Dear Editor,

Reply to Reviewer 1:

This manuscript presents sensitivity estimates for Br- and I- CIMS using the voltage scanning method. It follows several earlier studies where this approach has been utilized, and it is likely a useful addition to the growing literature on the subject. I recommend publication after revisions, and list my main comments and concerns below, with the major one relating to lack of novelty.

Figure S3. Signal variations of total ion counts (TIC), Br⁻ and H₂OBr⁻ (a) without a voltage bias and (b) with a voltage bias during the voltage scanning.

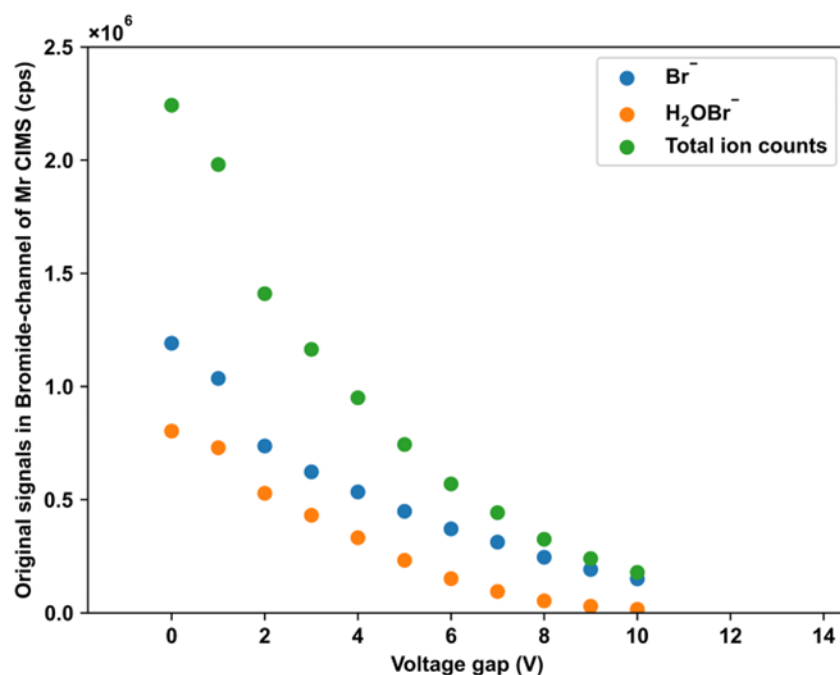
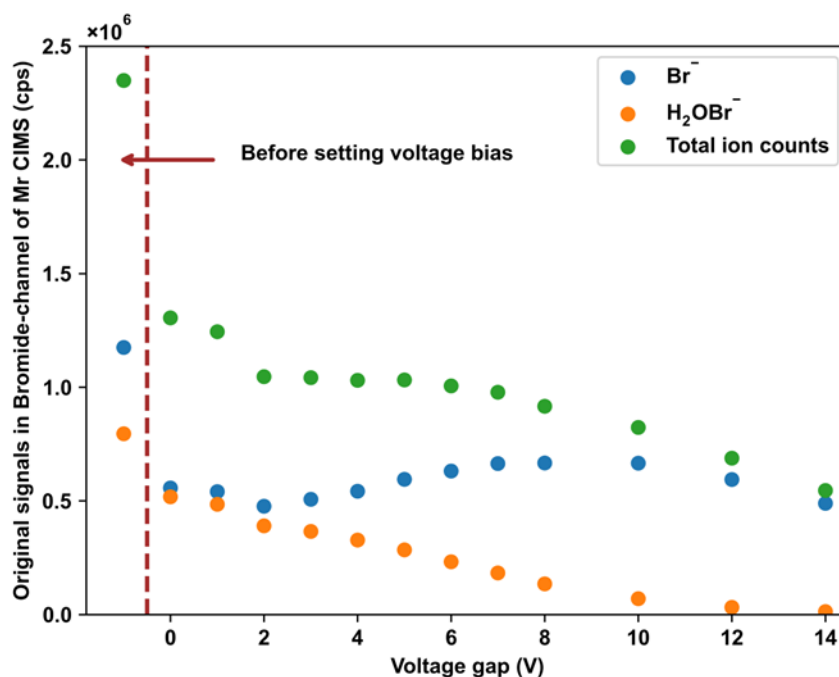
Comment1: It is not very clear to what the novelty in this specific work is. Lopez-Hilfiker et al. presented a very similar set of results for I- CIMS in 2016, and there have been several other papers following up with additional details after that. I started reading this manuscript with high hopes for some new insight, methodologies, or guidelines. In particular as the title said “From Signal to Sensitivity”, suggesting that the manuscript would contain new and in-depth methodology. However, now I have to suggest to the authors to more clearly showcase what this manuscript presents that is actually new in the context of “Atmospheric Measurement Techniques”. The authors themselves note in the introduction that “voltage scanning is one of the most frequently used semi-quantitative calibration methods”.

Reply1. We thank the reviewer for this comment. The aim of this study is to demonstrate how voltage scanning can be implemented in the newly developed Vocus AIM IMR, which is grounded and operates at a fixed potential. In addition, it provides theoretical and experimental insight into how different functional groups influence molecular sensitivity in Br-CIMS and I-CIMS.

In the revised manuscript, we present an expanded discussion on the necessity of implementing the voltage bias in Vocus AIM IMR and how this bias enables accurate voltage scanning results. The method is further applied to our Vocus CI-TOF, demonstrating that it is broadly applicable across instruments employing grounded IMR designs.

We revised Page 5, Line 10 to Page 6, Line 6 as: ‘The Vocus AIM IMR is configured to be electrically grounded, which differs from earlier CIMS designs (Lopez-Hilfiker et al., 2016). For anions, an increase in the voltage gap between SQ and BSQ will lower the potential of SQ relative to the grounded IMR and thus can generate a retarding electric field at the reactor exit. This will reflect ions back toward the IMR because anions are decelerated when moving toward regions of lower electric potential. A similar argument applies to cations in positive channels. This effect results in ion repulsion, i.e., reduced ion transmission, and can result in a decrease in ion signals. Consequently, the measured signal decay rate reflects not only the declustering

processes occurring after Skimmer, which indicates the cluster binding energy, but also variations in ion transmission across the IMR–SQ interface. Since voltage scanning is used to derive the cluster binding energy based on the signal decay, we have to minimize the above issue and ensure that signal decay rate is primarily determined by cluster binding energy.

Total ion counts (TIC) serve as a useful indicator of changes in ion transmission efficiency (**Figure S3**) (Lopez-Hilfiker et al., 2016). In this work a pinhole bias of -4 V in negative channels and $+4$ V in positive channels is implemented across the IMR–SQ interface, i.e., Reactor Back, at the start of scanning. This approach results in a fixed ion transmission offset from IMR to pinhole, but it ensures that the subsequent signal decay is dominated by variations in relative binding energies rather than by transmission artefacts from pinhole to SQ. This behavior arises because the strong gas expansion from IMR (~ 52 mbar) into SQ (~ 1.5 mbar) can efficiently drive the initial transport of ions, allowing anions to be transmitted with comparable efficiency from pinhole to SQ. It makes ion transmission relatively insensitive to variations in the SQ potential as long as the retarding electric field across the pinhole-SQ region remains moderate. Although ion transmission eventually decreases as the field becomes sufficiently strong, most clusters have already reached their dV_{50} by that stage.’

Figure S3 was added to help better understand the changes of transmission:

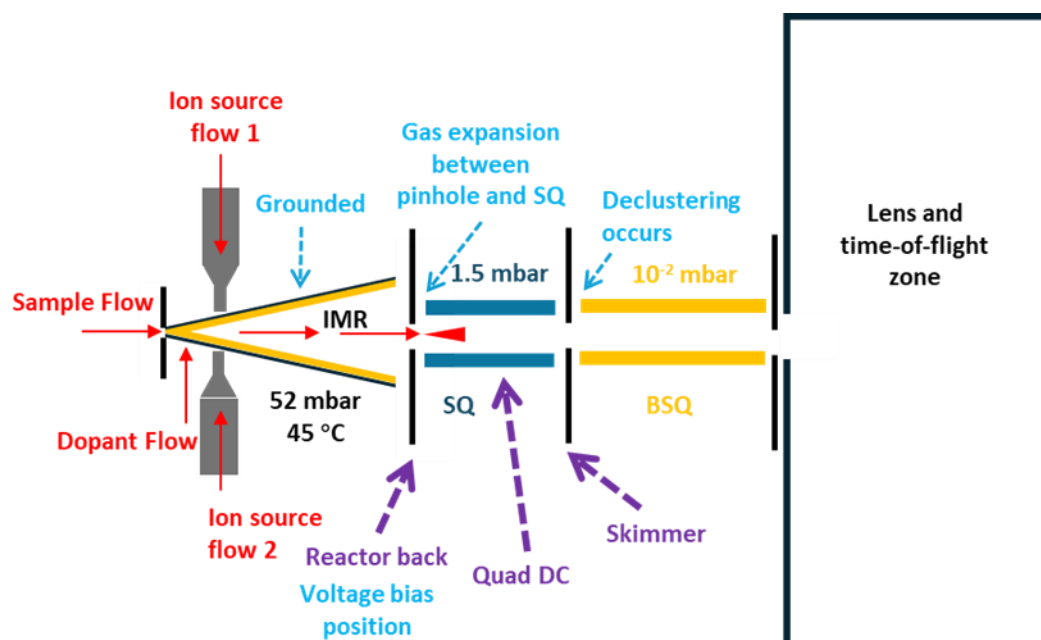
Comment8: Fig. 1, caption: I am used to seeing “SSQ”, but is the first quadrupole not segmented in this instrument? In addition, quadrupole is misspelled in the figure.

Reply8. The first quadrupole in our Vocus B and Vocus CI-TOF is not segmented. Riva et al. reported that the optimal voltage gradients in the first quadrupole region are typically all 0 V between electrodes, as ions are focused on the radial direction efficiently by the RF but transported axially by the gas flow (Riva et al., 2024). Consequently, Tofwerk opts not to implement a segmented quadrupole.

Thank you for pointing out the spelling error. We have revised this figure according to reviewers’ comments as:

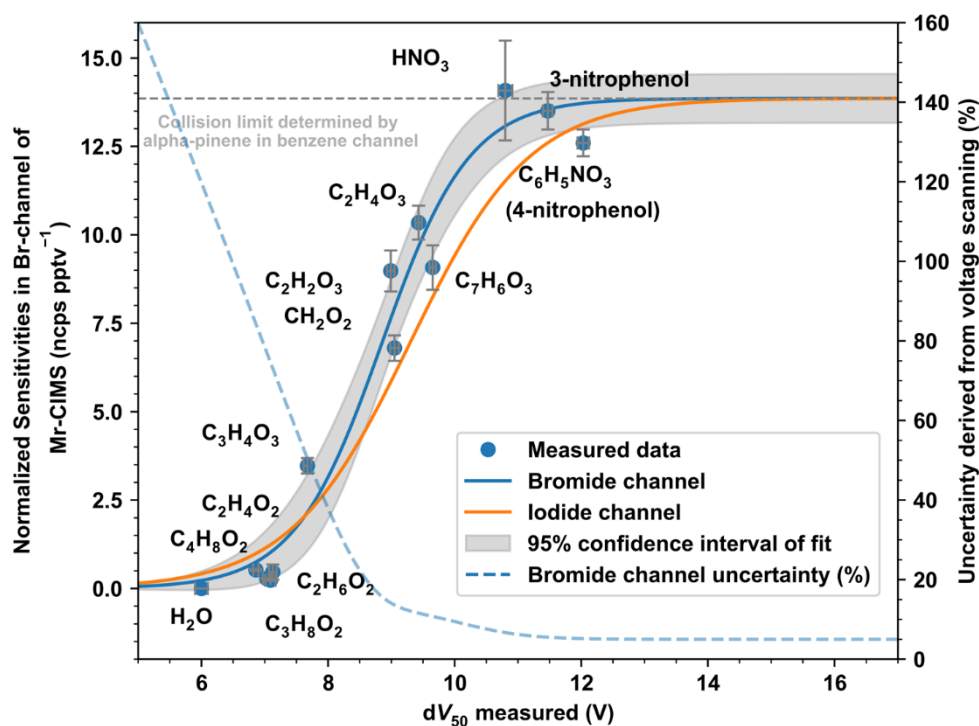
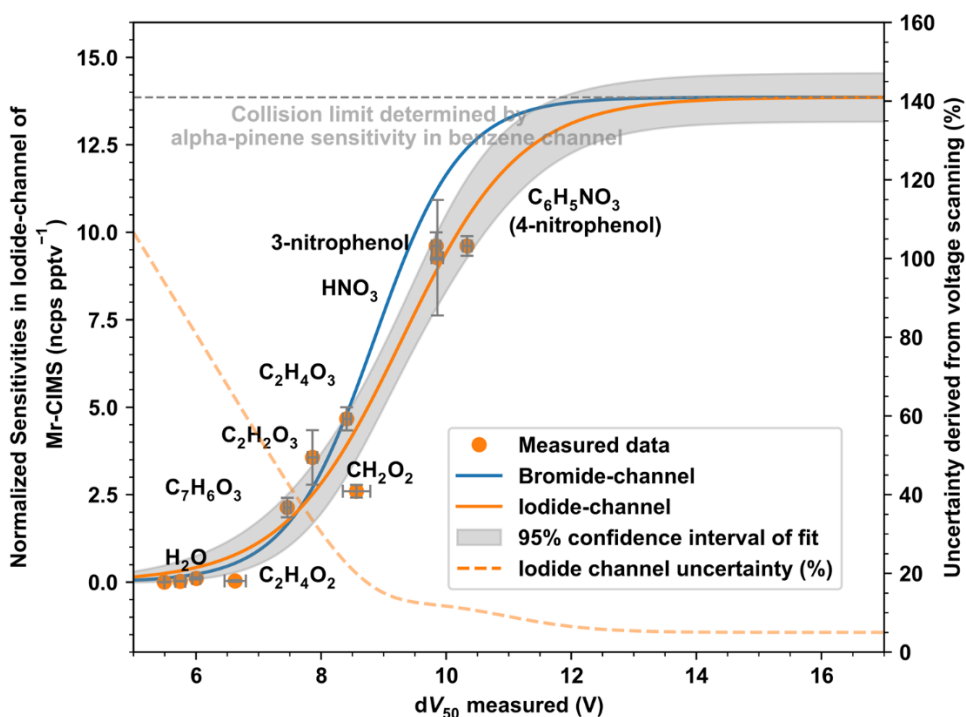
Comment11: Figure 2: 1) The figures have two lines that refer to “uncertainty”, and they are very different, and on different axes. 2) nitrophenol is misspelled in panel a. 3) Having the “l” in the formulas in panel b in the middle of the formulas, although they are adducts with I-, seems incorrect.

Reply11. 1) We already explained the uncertainty in the Page 7, Line 2 – 4 of original manuscript: ‘The uncertainty in the estimation was defined as half the width of the 95% confidence interval of the sigmoid fit, divided by the corresponding fitted value, and was also treated as a systematic error associated with the use of this method.’ The shadow indicates ‘half the width of the 95% confidence interval of the sigmoid fit’. The right axis is the systematic error, which is the sum of squares of 5% uncertainty from collision limit determination and the standard error of sigmoid fit divided by the corresponding fitted value. This is further explained this in the revised version. 2) Revised. 3) We followed the ion formulas detected by mass spectrometer. To avoid misunderstanding, we only labelled formulas of analytes in the revised version.

We revised Figure 2 as:
